ANN ARBOR HISTORIC DISTRICT COMMISSION

Staff Report

ADDRESS: 514 Sixth Street, Application Number HDC25-0147

APPLICATION: The applicant seeks HDC approval to alter the non-contributing garage by adding a second floor and a two-story addition.

1 SITE PLAN
SCALE: 1" = 10'

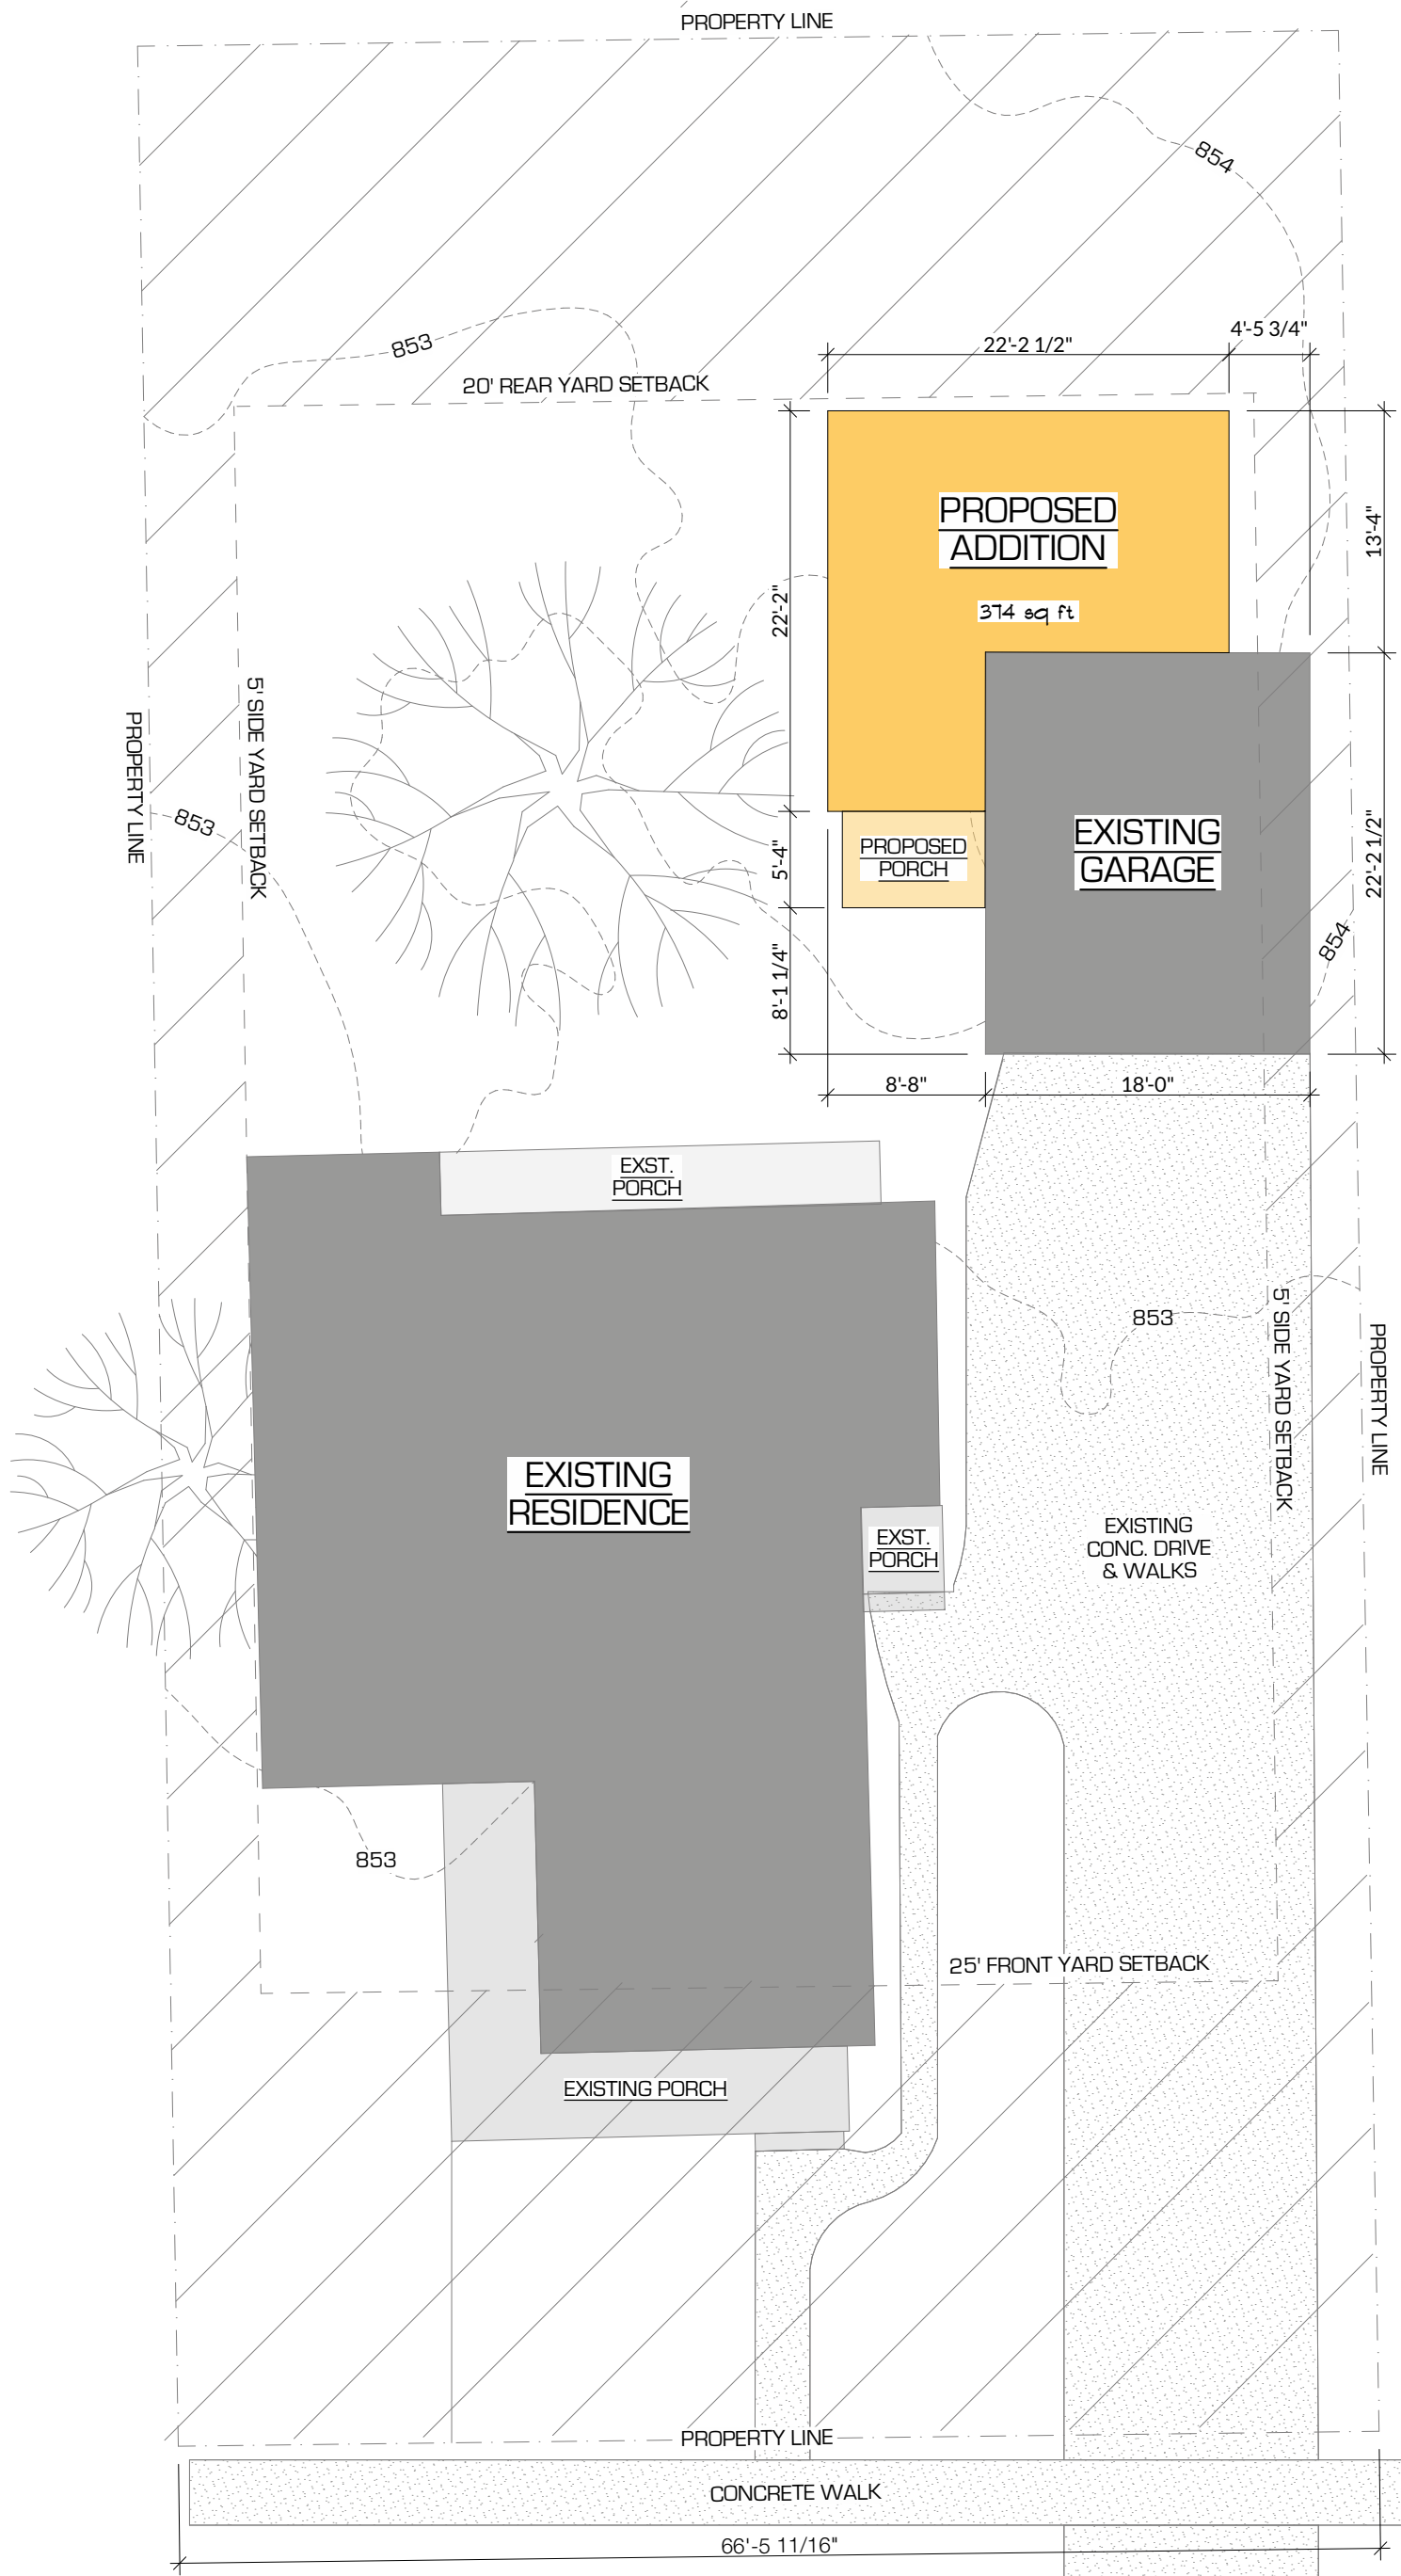
1. The footprint of the garage is currently 18' wide by 22'2 1/2" deep, or 400 square feet. This is the size that staff typically recommend as a maximum for accessory structures on full-sized Old West Side lots (which are typically around 65' x 130' like this one). The addition has a 374 SF footprint behind (west) and on the south side for a total footprint of 774 SF and would result in a 1,466 sf structure (400 SF garage + 703 SF ADU + 293 SF workout studio + 70 SF entry/mudroom).

4. In a review-of-drawings email to the architect, staff stated their opinion that the structure is too large and too close to the house and recommended shrinking the footprint and height and pushing the structure toward the rear of the lot to get more distance between the house and garage.

The proposed work is not compatible in massing, size and scale to the historic house on the property and to neighboring structures and does not meet SOI Standard 9. The historic house on this lot has previously had many additions on the sides and rear (which, it should be noted, the current owners have tried to make more compatible with the historic part of the house). Staff's opinion is that adding another structure that matches the size of many typical Old West Side houses in such close proximity to the house (8 ½ feet from the rear corner) makes the massing, size, and scale inappropriate under SOI Standard 9.

Staff believe the size and closeness of the structure to the house does not preserve the historic relationship between the house and yard, landscape features and open spaces.

Staff believe the largeness of the structure makes it visually incompatible and that it also further destroys the relationship between the house and yard, where documentation to date does not show any outbuildings historically.

9. Staff believe that the proposed work is out of scale with the historic house and located too close to it and does not meet the *Secretary of the Interior's Standard 9* or the *Secretary of the Interior's Guidelines for Rehabilitation* or the *Ann Arbor Historic District Design Guidelines* and recommends denial of the application. The application can be improved by shrinking the footprint and height of the structure and pushing it to the rear of the lot.

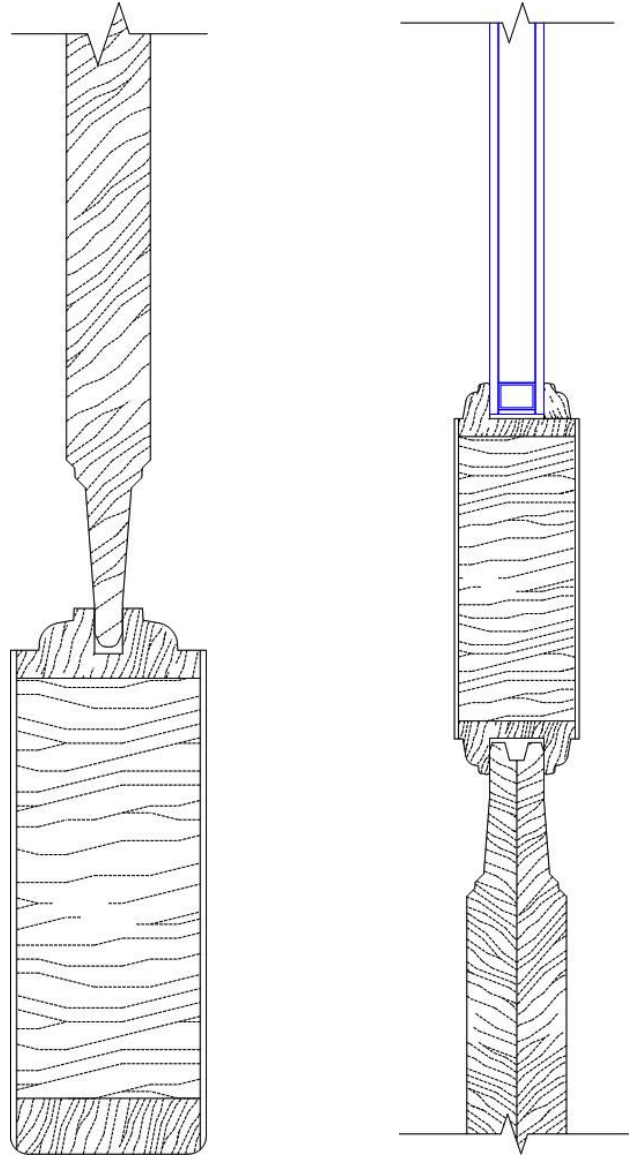
2. Project materials include fiber-cement siding with 4" maximum exposure and wood grain finish. Since the structure is separate from the historic house, the wood grain finish is appropriate (though smooth side out would look more like a painted wood surface). Windows are clad casements, though the cladding material is not specified. Window trim is cedar and was intentionally varied slightly from the historic window trim dimensions on the house.
